**Meeting Minutes Transmittal/Approval  
Unit Managers Meeting: Grout Treatment Facility**

Meeting Held January 22, 1992  
Washington State Department of Ecology  
7601 West Clearwater Avenue  
Kennewick, Washington

Engineering Change Notices: B-174-107, 108, and 109

Proj. ECN B-714-107

REFERENCE DWG H-2-77582, SH 1, REV 1 and H-2-78451, SH 1, REV 1.

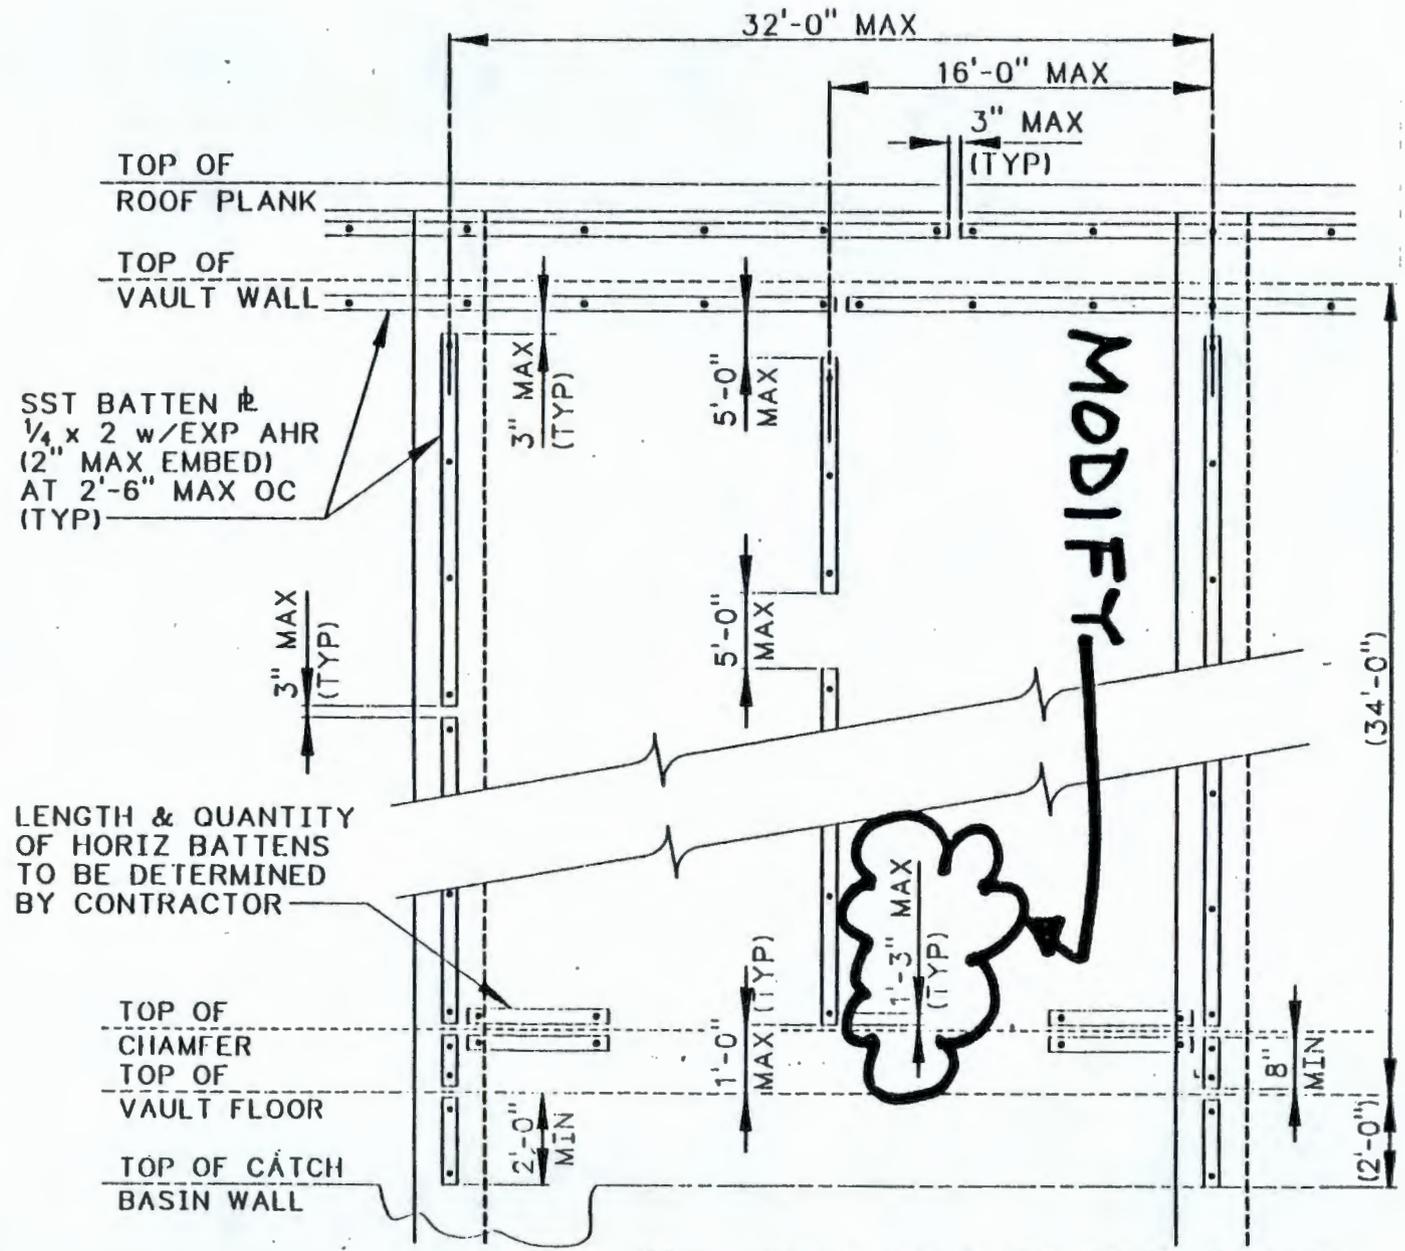
- 2) H-2-77581, Sh 3, Rev 1 (affects ECN B-714-94, pg 9)  
Concrete Topping Plan: Change 54.25' to 56.75'
- 3) H-2-77582, Sh 1, Rev 1 (affects ECN B-714-97, pg 4)  
Section B: Modify - See page 4 of this ECN.

- 4) H-2-77598, Sh 1, Rev 1  
Plan (ZE7): Modify - see page 5 of this ECN.
- 5) H-2-78451, Sh 1, Rev 1 (affects ECN B-714-97, pg 4)  
Section B: Modify - see page 4 of this ECN.

NOTE: WHERE NECESSARY, ROUND CORNERS OF BATTEN PLATE OR PLACE 60 MIL HDPE RUB SHEET UNDER BATTENS TO PREVENT DAMAGE TO CURTAIN.
